Department of Energy
Office of Legacy Management

Subject: ~~Naturita~~ and Slick Rock, Colorado, Sites

Responses to Bill VonTill Questions for May 3, 2005 Visit

Naturita Processing Site (NAT01)

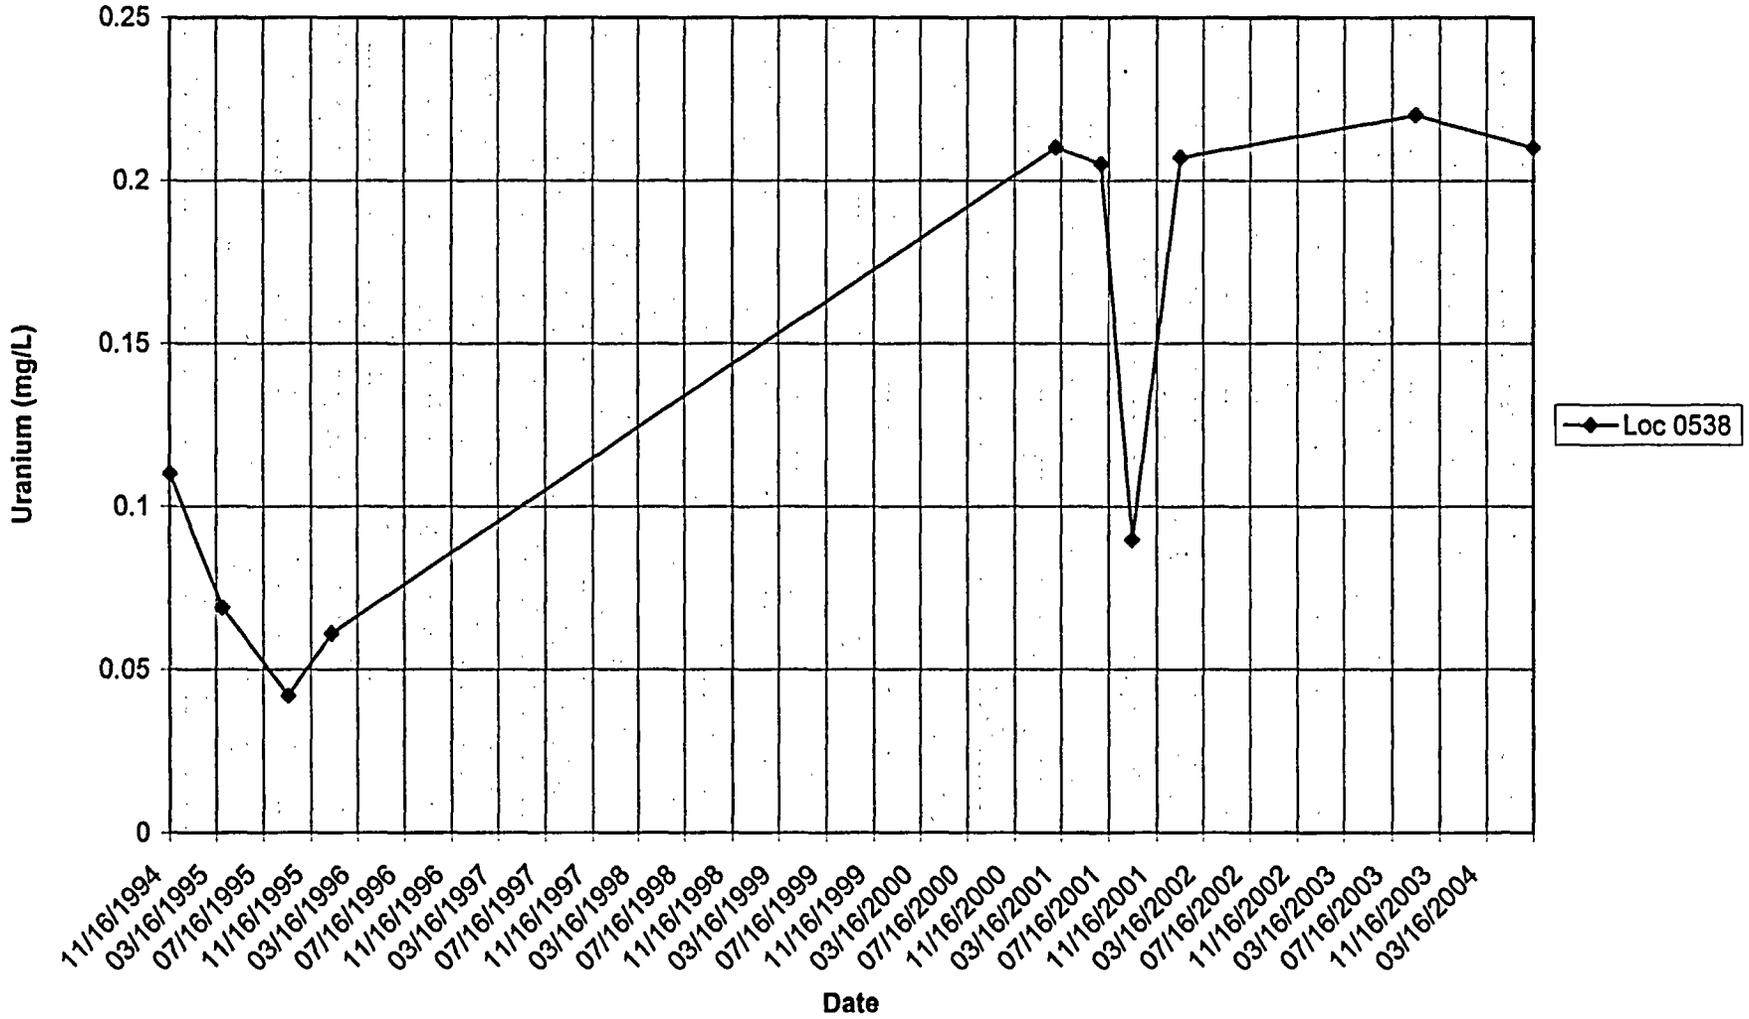
1. Q. Is uranium increasing at the seep?
A. A time/concentration graph for the seep at Naturita, location 0538, is enclosed. It shows an increase from sampling conducted in 1994 – 1995 to sampling started in 2001. From 2001 forward, it shows a fairly steady concentration. The reason for the low value in late 2001 is unknown.
